ADDENDUM NO. 2 TO PROJECT NO. 45011

**CONSTRUCTION WORK, HVAC WORK, PLUMBING WORK, ELECTRIC WORK
PROVIDE COMBINED SUPPORT MAINTENANCE SHOP
CAMP SMITH
11 BEAR MOUNTAIN BRIDGE ROAD
CORTLANDT, MANOR, NY 10567**

August 5, 2015

SHEET TITLE
REVISED OIL WATER SEPARATOR CONFIGURATION
REFERENCE SHEET C-401

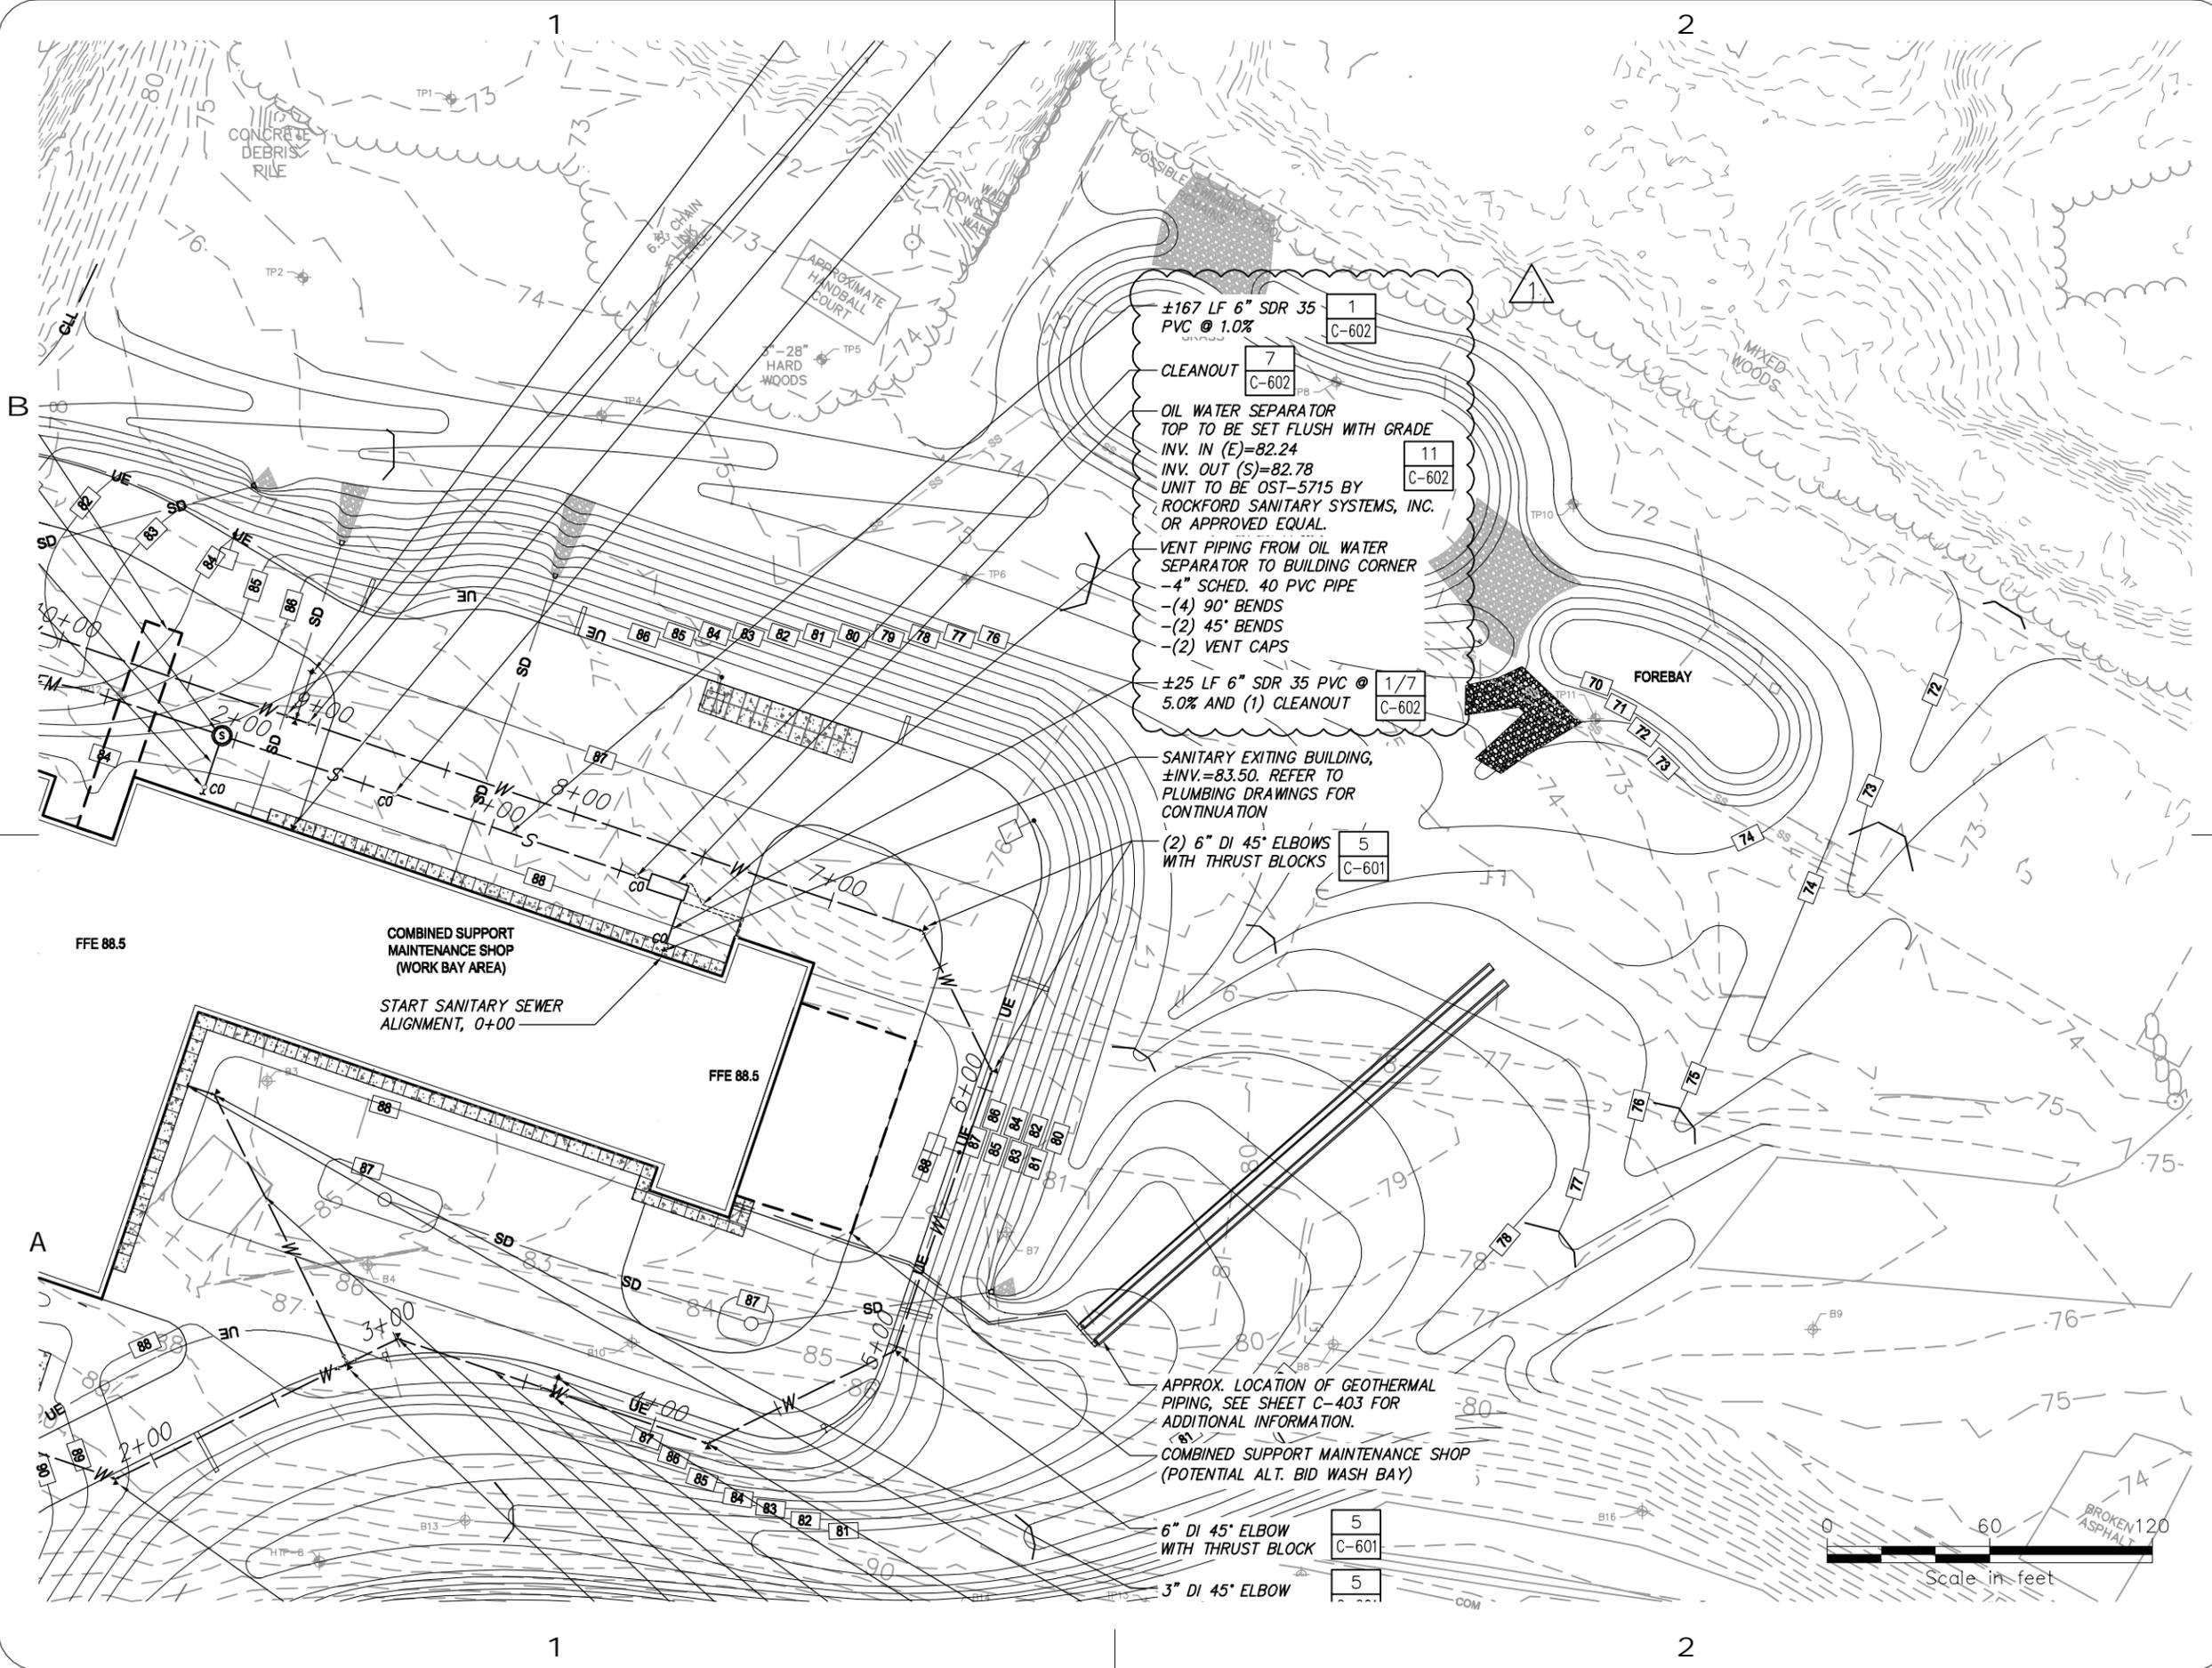
- b. Identified material of forcemain as HDPE in callout. See SKC-001 Addendum Drawing dated August 4, 2015.
 - c. Revised Oil/Water Separator configuration and callouts. See SKC-002 Addendum Drawing dated August 4, 2015.

SHEET TITLE
 REVISED OIL-WATER SEPARATOR NOTES
 REFERENCE SHEET C-602

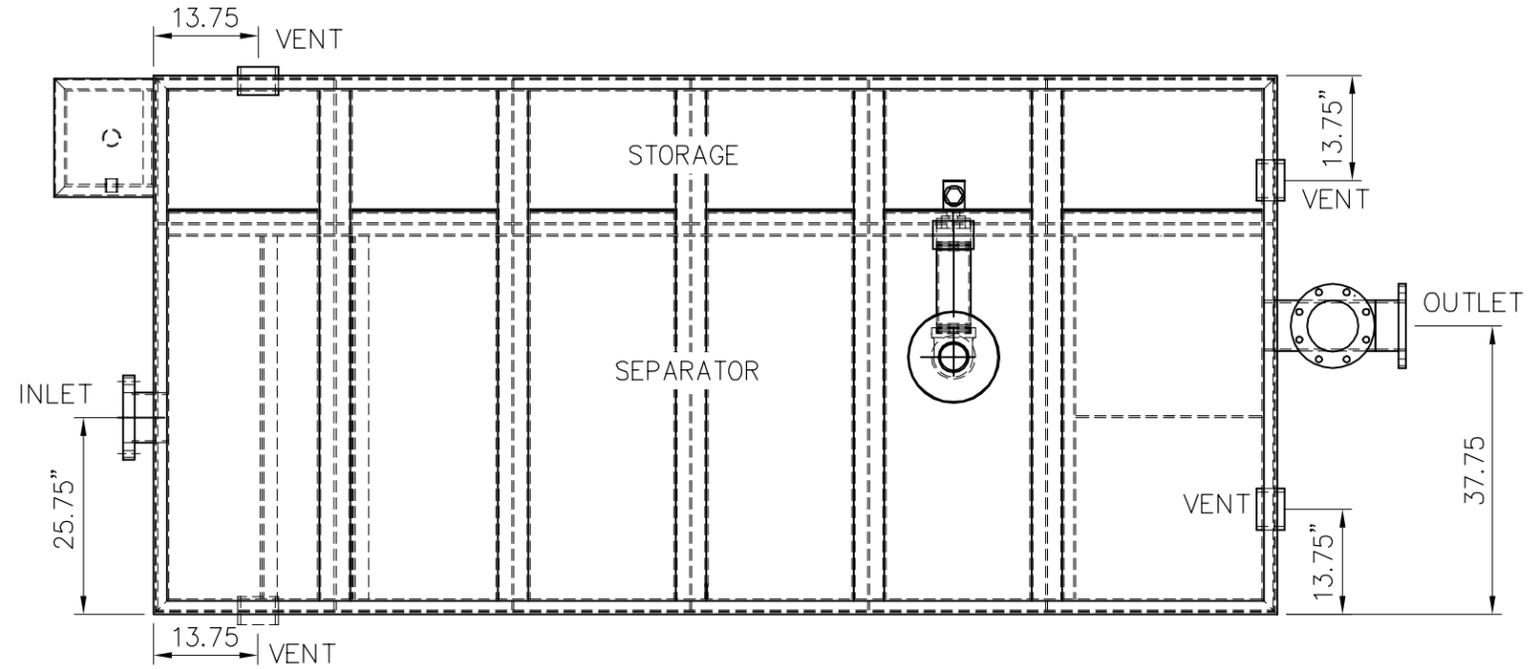
14. Drawing No. C-602
 - a. Denoted that the OWS is 1,250 gallons. See SKC-003 Addendum Drawing dated August 3, 2015.

- 1,250 GALLON OIL-WATER SEPARATOR TO BE ROCKFORD SANITARY SYSTEMS MODEL OST-5715-500 OR APPROVED EQUAL.
- CUSTOM CONFIGURATION REQUIRED FOR INLET.
- STANDARD CONFIGURATION IS FOR FLUSH INSTALLATION. THE INTEGRAL EXTENSION (OPTIONAL FEATURE, ADDITIONAL COST) WILL BE REQUIRED BASED ON PROPOSED INSTALLATION DEPTH, TO BRING ACCESS TO GRADE. EXTENSION REQUIRED PER DESIGN PLANS IS ±39.25" ON THE EAST SIDE, AND ±38" ON WEST SIDE (NORTH AND SOUTH SIDES TRANSITION EVENLY BETWEEN). CONTRACTOR TO VERIFY HEIGHT BASED ON FINAL GRADING AND UTILITY PLANS PRIOR TO ORDER.
- FRAMES TO BE SET FLUSH WITH PROPOSED FINAL GRADE AND CAPABLE OF WITHSTANDING H-20 LOADS. THIS IS A REQUIRED OPTIONAL FEATURE AT ADDITIONAL COST.
- OTHER REQUIRED OPTIONAL FEATURES (ADDITIONAL COST) WILL BE: DOUBLE WALL CONSTRUCTION, HIGH LEVEL SENSOR AND ALARM, COALESCING PACK, AND LIFTING LUGS.
